CNL-16-117

Browns Ferry Nuclear Plant, Units 1, 2, and 3  
Renewed Facility Operating License Nos. DPR-33, DPR-52, and DPR-68  
NRC Docket Nos. 50-259, 50-260, and 50-296

Subject: **Proposed Technical Specifications (TS) Change TS-505 - Request for License Amendments - Extended Power Uprate (EPU) - Supplement 26, Responses to Requests for Additional Information**

**ENCLOSURE 2**  
**Responses to NRC Requests for Additional Information**  
**EMCB-RAIs 1, 4, 5, 6, 7, 8, 12, 20, 23, 25, 28, 33, 35, 38, 39, 40, 41, 42, and 43**

**Figure 38c-1 (Figure I-9.2.2) Design Feature Curves for Austenitic Steels, Nickel-Chromium-Iron Alloy, Nickel-Iron-Chromium Alloy, and Nickel-Copper Alloy for  $S_a \leq 28.2$  ksi, for Temperatures Not Exceeding 800°F (For  $S_a > 28.2$  ksi, use Figure I-9.2.1)**

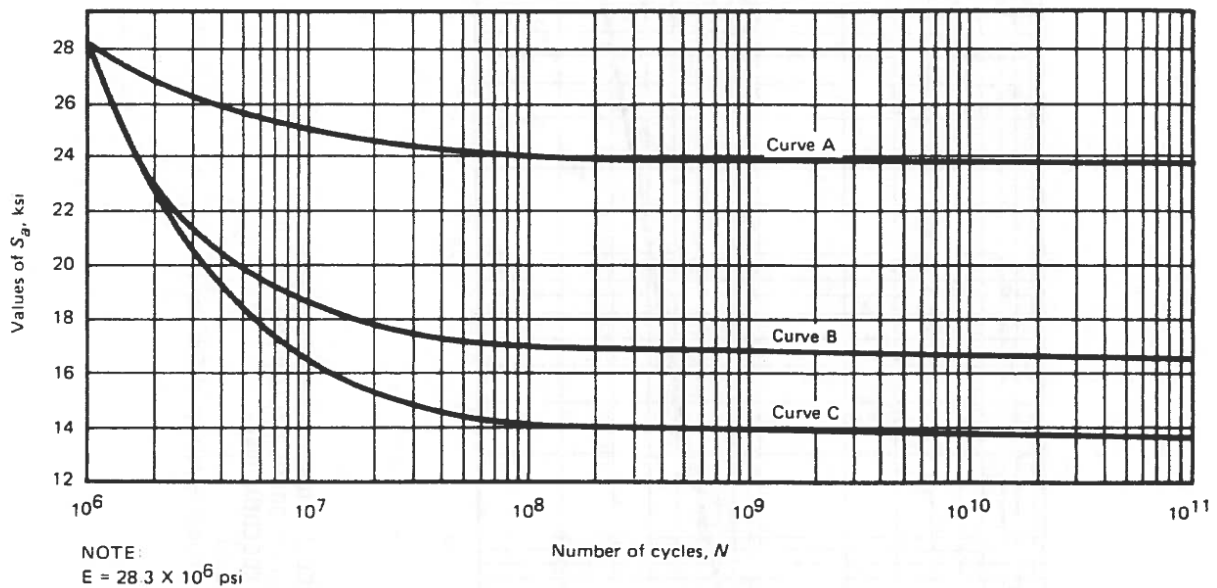
- c. SGs 6 and 9 have very high potential strains – up to [[ ]]. SGs have a finite life, particularly at high amplitude. Provide information on which frequency(s) contribute most strongly to the strain at these gage locations. Describe the survivability (expected life or number of cycles) of the dryer SGs at these potential strain amplitudes.

The use of the Ni-Cr-Fe fatigue Curve C (Figure 38c-1) from the American Society of Mechanical Engineers (ASME) Section III (Division 1, Appendix I, 1995) for the fatigue evaluation on the strain gage product (with the wire made of Ni-CrV) is considered conservative.

**Figure 39-2. Typical Responses of One-Degree Elastic Systems (Un-damped) Subjected to Symmetrical Triangular Load Pulse (T is the natural period of the system)**

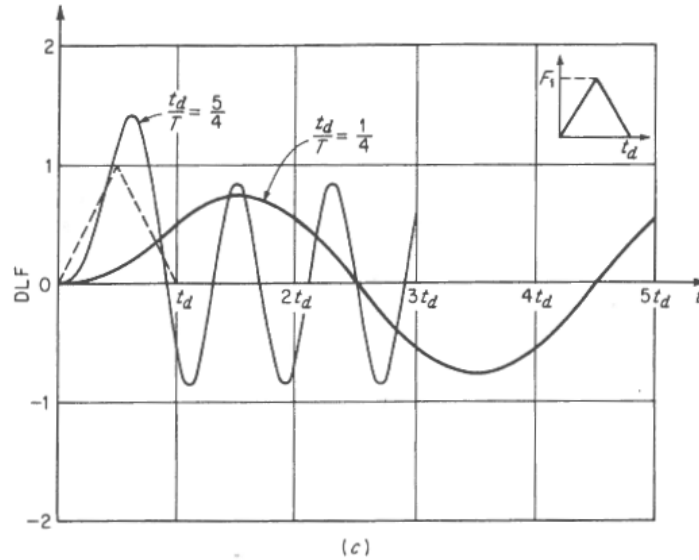
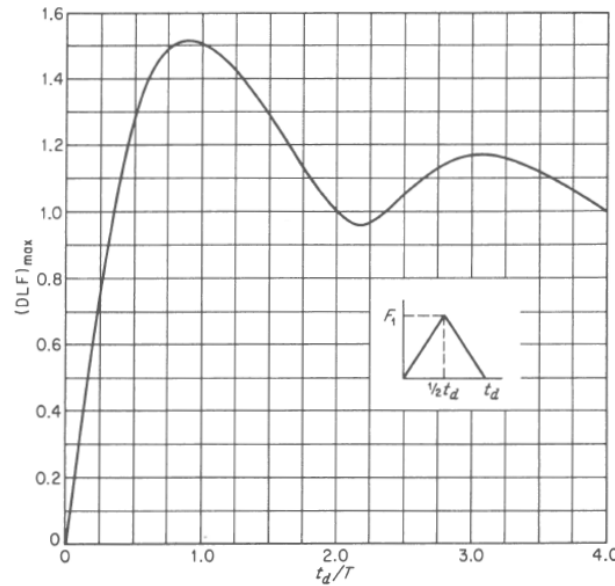
- a. Table 8.1-4 of Appendix-A (p. A-88 of Reference 8) states that a [[  
]]. Provide the numerical value of the [[  
]] used in the static analysis. Also, provide a justification for the magnitude of the [[  
]] value.

Because deflection, spring forces, and stresses in the linear elastic structure analysis are all proportional, the response. In Reference 39-1 the responses for one-degree elastic systems (un-damped) subjected to symmetrical triangular load pulse are calculated. Figure 39-2 (Figure 2.6(c) in Reference 39-1) shows the typical responses for this type of forcing function which start at zero and reach a maximum  $F_1$  at one-half the total force duration  $t_d$ , with  $T$  as the natural period of the system. The maximum response as a function of  $t_d/T$  is given by Figure 39-3 (Figure 2.8(a) in Reference 39-1).

**Figure 43-1. Finite Element Model Description for Test Case VM39 with Vertical Force Applied**

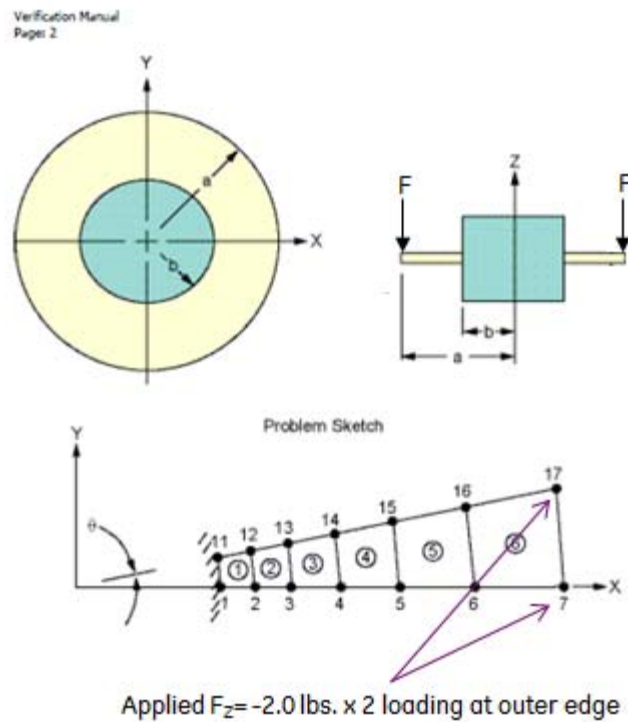
Provide a quantitative justification that ANSYS shell elements used to model the steam dryer in the finite element structural analysis of the steam dryer adequately capture peak stresses.

To determine the consequence of the transverse shear assumption in the ANSYS element formulation for the three element types, SHELL181, SHELL63, and SHELL43, a simplified study using the ANSYS verification manual test case VM39 (Reference 43-1) was performed. This test case uses a 10° sector of a circular plate with a center hole to study the differences between the three element types (see Figure 43-1). The plate thickness for the study is 0.25 inches and the inner (b) and outer (a) radii are 10 inches and 30 inches, respectively. For the material, the elastic modulus is 30 MSI and Poisson's ratio is 0.3. Symmetric boundary condition configurations are applied along the two radial edges with the inner diameter constrained in all six degrees of freedom. In order to test the transverse shear effect, the loading is modified as a total 4 lb. vertical force applied evenly at outer edge two nodes (Nodes 7 and 17) of the 10° sector as shown in Figure 43-1. This simplified test case configuration is similar to the [[ ]].

Table 43-1 shows comparisons of the outer edge deflection and the element component stress  $S_X$  in X (~ radial) direction for the inner diameter (Element 1) and outer diameter (Element 6) elements using the SHELL181 (ANSYS recommended element type) results as a base reference. The comparisons show the differences to be insignificant. However, the SHELL43 results are virtually identical to the SHELL181 results for the case analyzed.
